### MODIFICATION SHEET NO. RDSO/WAG 5/31

- 1. <u>Title</u>: Modification in the pinion end portion of armature shaft of Traction Motor type HS 1050Er/HS15250A.
- **2. Application**: Traction Motor type HS 1050Er/HS15250A.
- **3.** Object: Railways have reported some cases of the failure of Traction motor type HS1050Er/15250A due to bearing seizure/damage of pinion teeth or sliping of pinion at its seat. All these failure require the removal of pinion from the armature shaft.

### **AMENDMENT NO. 1**

**Sub:** Amendment to modification in the pinion end portion of armature shaft of Traction Motor type HS 15250A/HS 1050Er.

- RDSO Drg. No. SKEL. 4453.(copy enclosed)
- Pinion Retaining circular plate : RDSO Drg, NO. SKEL.

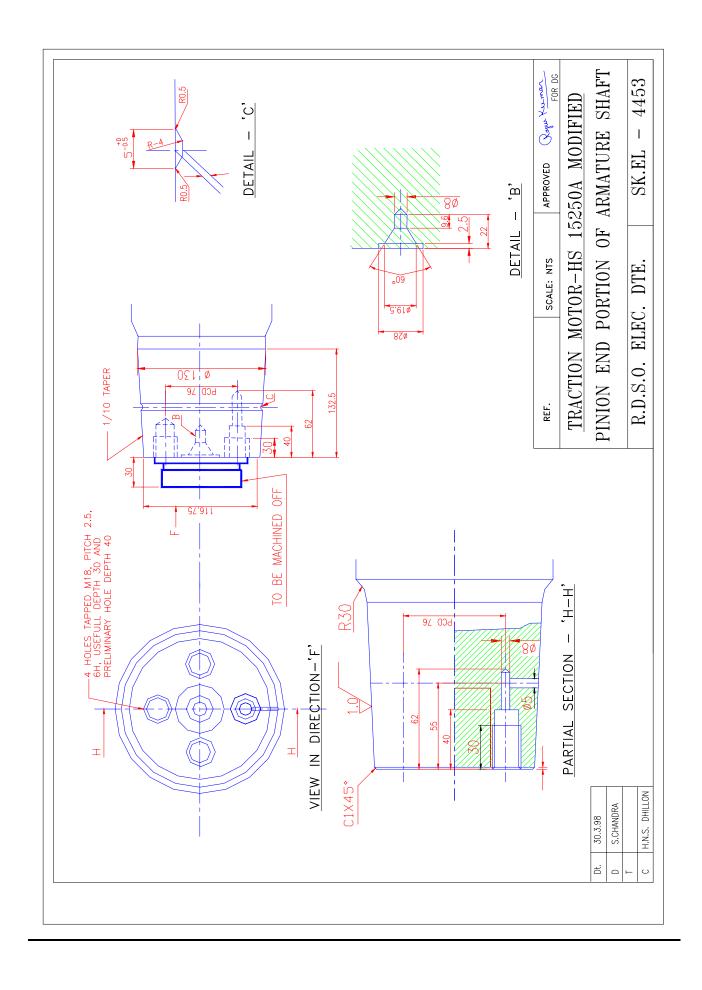
Railways have also reported that sometimes the threaded portion of the armature shaft becomes worn out and sheds are facing problem to fit the pinion hexagonal nut in position properly, which may result slacking of pinion on line. Damage to these require reshafting of armature which is a major repair work. Hence, this defect may be treated as type on this Traction Motor.

The matter has been discussed in the 25th MSG/EL held at Secunderabad on 5th & 6th March '1998 and it is decided to modify the pinion end portion of the armature shaft of Hitachi Traction Motor in line with TAO-659 armature shaft and also adopt the TAO. 659 holding arrangements for pinion.

- Remove existing pinion hexagonal nut M80.
- Remove pinion lock washer.
- Remove pinion.
- Dismentle the Traction Motor as per usual procedure.
- Modify the pinion end portion of the armature shaft as per RDSO Drg. No.SK. EL. 4453.
- Machine off the portion as marked by thick dark line on the above drawings.
- Drill & tap 4 holes size M18, Pitch 2.5 mm, useful depth 30mm preliminary hole depth of 40 mm.
- Chamfer the PE face of armature shaft as above drawing.
- Reassemble the armature as per usual process.
- Mount the pinion
- Fit the pinion retaining circular plate and hold this with 4 hexagonal head bolts size M18X30L, pitch 2.5 and double locking plates.
- Tighten these four M18 bolts by torque wrench.

4454.

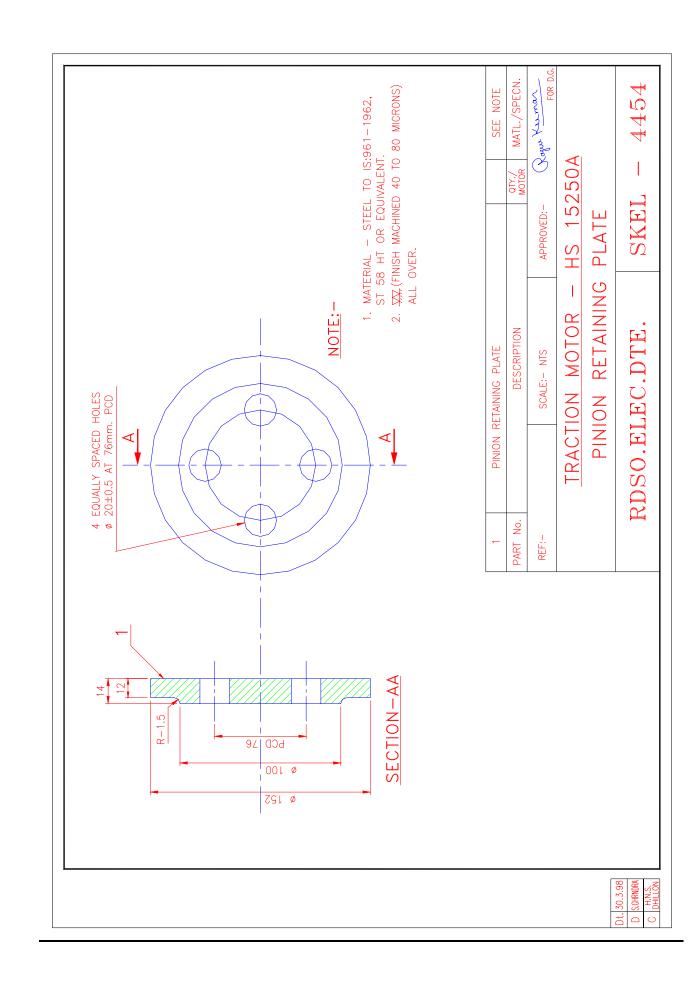
- Pinion Retaining plate as per RDSO SKEL. Drg. No.4454.
- Double locking plate as per RDSO Drg No. SKEL. 4455.
- Hex head bolt size M18X30L, pitch 2.5
- Armature shaft with modified pinion end portion.
